Your feedback on: Orewa Boulevard Improvements

From 25 May – 22 June 2020 the public were invited to provide feedback on proposed safety and accessibility improvements to Orewa Boulevard in Orewa. In total **205 submissions** were received.

Attachment 1: Designs released for public feedback

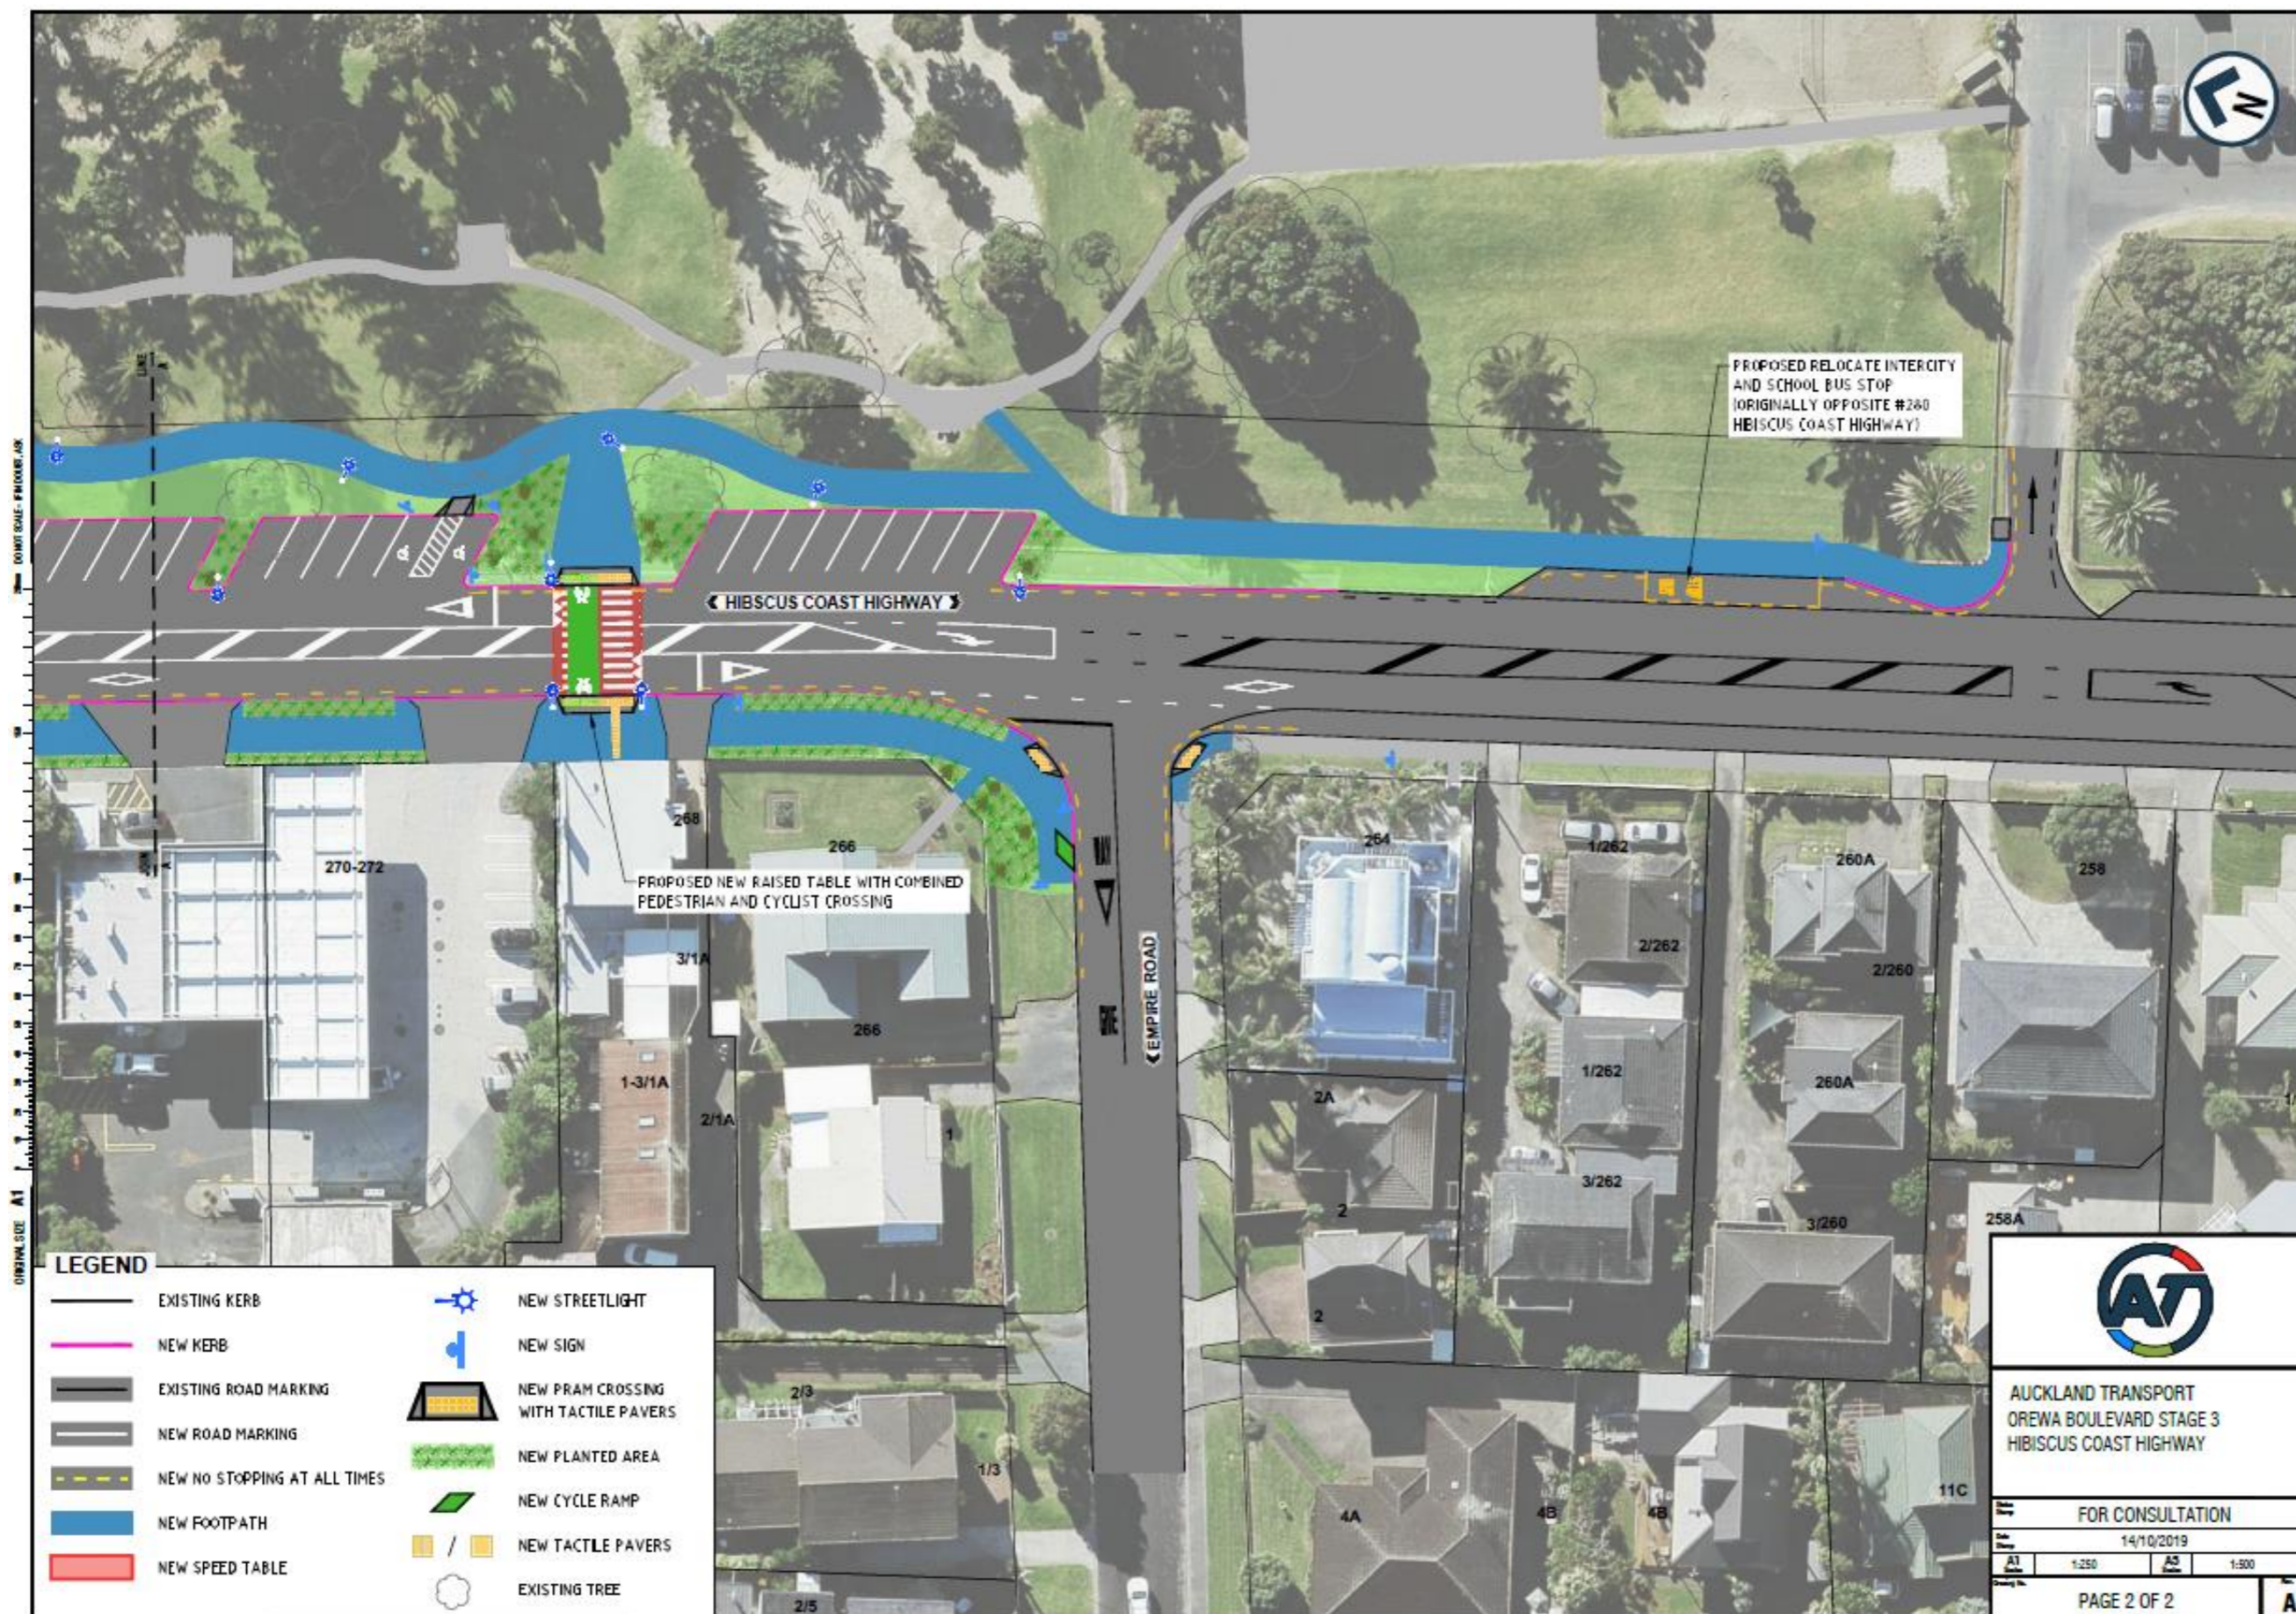
- the shared path on the seaside should be much less "wiggly". Otherwise, it is of much less use, and both pedestrians and cyclists will weave across the path to reduce the annoying sideways detours, making it very unpredictable where a person might walk, leading to risks of riders hitting a pedestrian from the rear.

- the design drawing implies the building-side vehicle crossings have priority over the shared path. Both for practical, safety and legal reasons, the design should instead strongly indicate the opposite. This needs to be made part a key of the design to slow down crossing traffic, whereas this drawing implies (even for the designers of the next project stage) vehicle priority.

- The south end of the shared path is missing a ramp for riders to go on / off it.

- Please narrow the very wide traffic lanes at the south end to allow the bus stop kerb to be at least 1m distance away from the shared path edge (bus boarder style) rather than having bus passengers step right into a cycle facility.

- Please traffic calm (ideally place a raised table across) the car park one-way entry at the south end of the shared path.

The raised pedestrian crossings need to be designed to cater for over dimension loads - they must be no more than 80mm in height above the road surface and have a gentle slope.

The "wiggly nature of the shared path has been necessitated by the need to by-pass root zones of the large trees. It is expected that cyclists should exercise caution when using the path.

The crossings on the consultation drawings are shown in different colours to highlight that they are crossings. The surface materials for crossings will be the same as for the west side footpath. Turning vehicles will be expected to exercise caution when turning into crossings, as will pedestrians and cyclists using the shared path.

This has now been added to the design drawings

Following further consultation with AT Metro and bus operators, the parking area on at the south end (East side of road) will remain as a parking area, not a bus stop.

Traffic entering the carpark at this location will already be travelling at a reduced speed, and the cost of an additional speed table in this case cannot be justified.

The height of the tables will be 75mm
